#

W.P. #182-63-02

HWY. #2, C.N.R.

## FOUNDATION INVESTIGATION REPORT

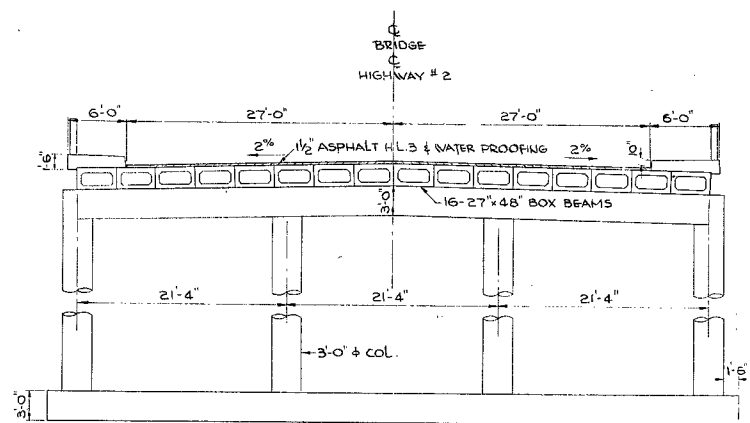
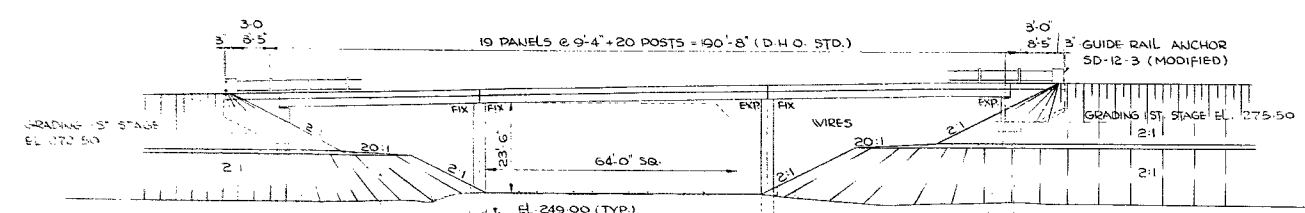
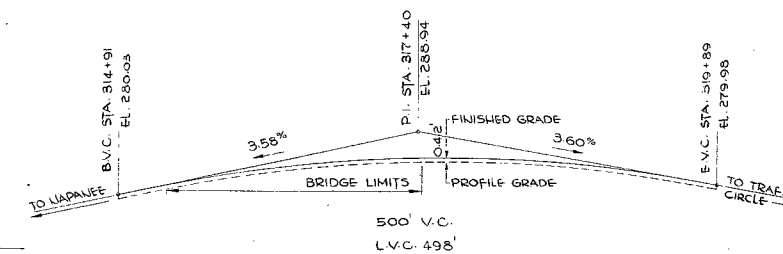
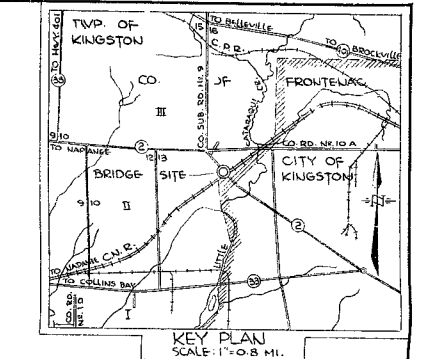
Would you kindly review the bridge foundations proposed and inform us if they are satisfactory.

- 1) No comments regarding the structure foundations
- 2) Any stability problems between Sta 32+00 and Sta 33+00 will be discussed at a later date when additional information is available from Mr. J. Graff.

## DEPTH OF SOFT MATERIALS.

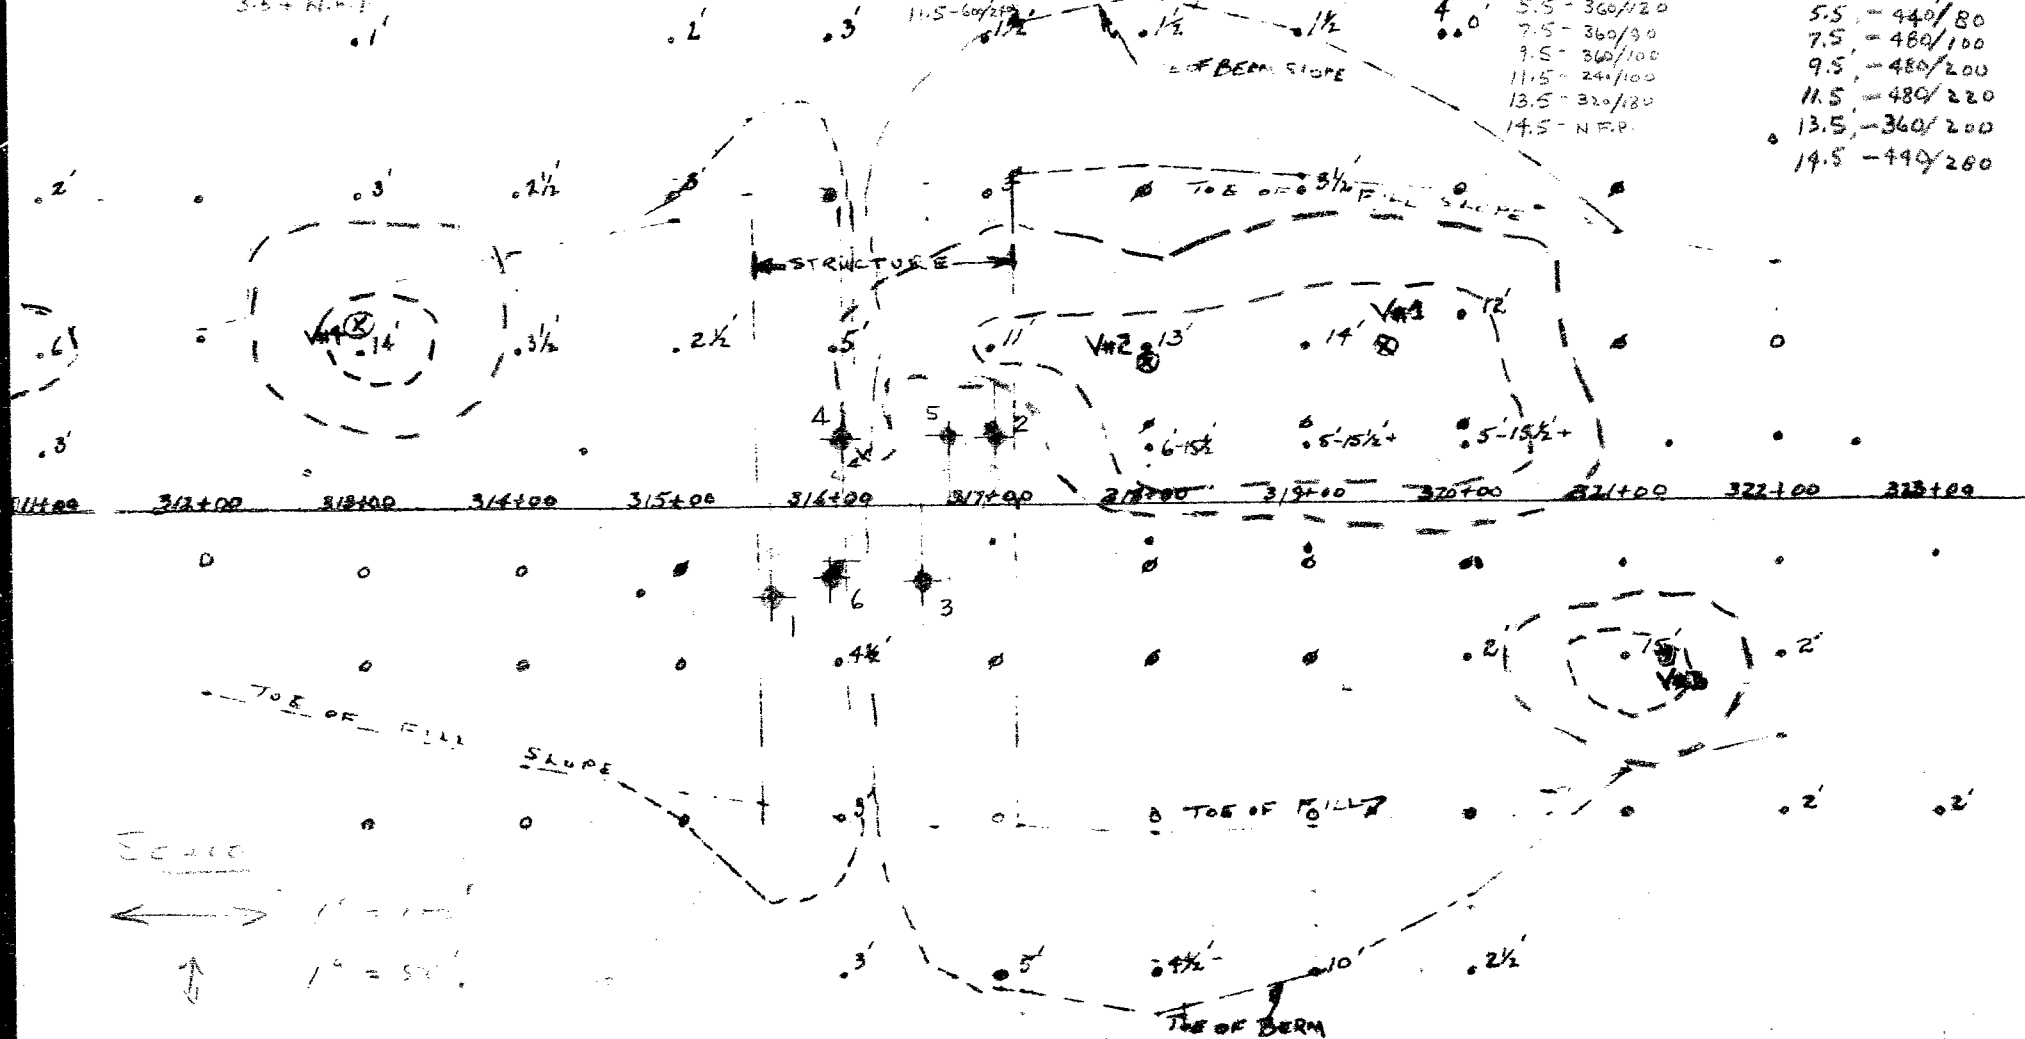
Further to our discussion a few days ago, enclosed is a sketch showing the locations of soundings carried out in the vicinity of the railway crossing at Cataragui.

The depths indicated adjacent to the boreholes are the depths of soft materials. The blue broken line indicates the approximate 5' contours of soft materials and the broken red lines indicate the approximate contours of the 10' depth of soft materials. A few of the borings in the vicinity of Sta. 318 to Sta. 320 indicate soft materials from 6' - 15½' or 5' - 15½'. The initial 5' is the existing fill of Hwy. 2 with a remaining depth of soft material down to a depth of 15½'.

Vane tests were carried out at several of these locations, three of them being completed and the fourth could not be obtained due to layers of sandy materials. It is felt that the soft materials should be excavated down to the maximum depth shown. Where soft materials underly the existing Hwy. 2 fill, excavation should only be carried out on the widening with no excavation of the existing roadway fill.

I would be pleased to hear your comments on our proposals as to whether you are in agreement or feel that some other form of treatment is necessary.

1/ Can we use ~~table~~ m

2/ organic or also soft material

3/ Berms still after removal & replacement

HORIZONTAL CLEARANCE OF STRUCTURE AT C.N.R.  
CROSSING & HWY NO. 2 "CATARAQUI"

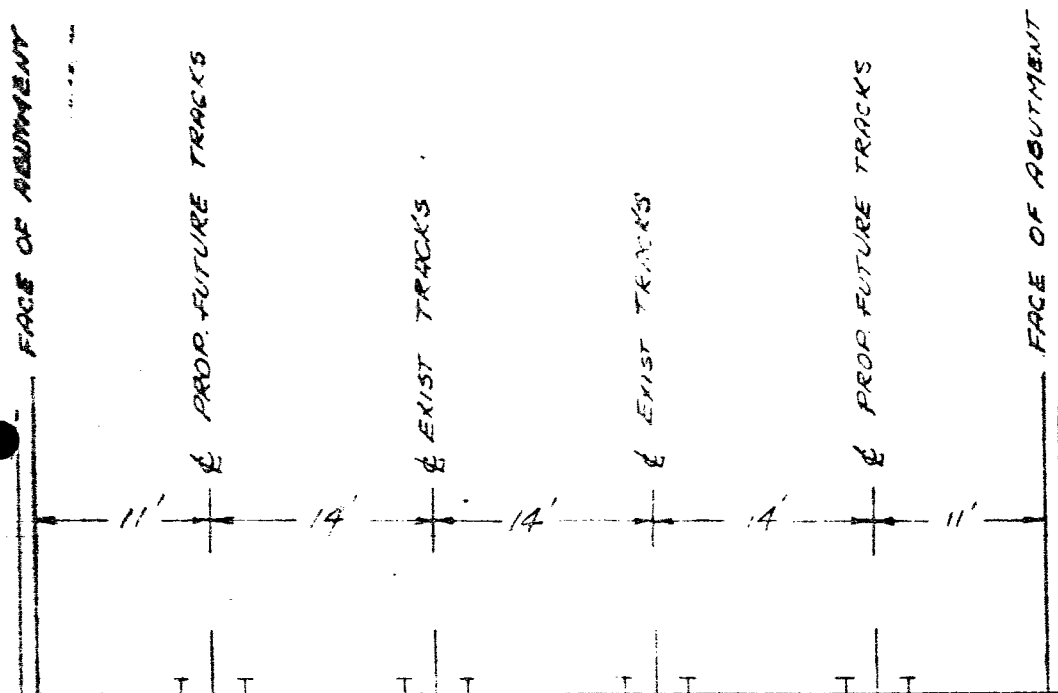
The structure over the C.N.R. railway at the above location is to be built to accommodate two future additional tracks as shown in the attached sketch.

Provision for two additional tracks means that the clear span required at this structure will be 64' rather than the 36' stated in the Functional Report for this project.
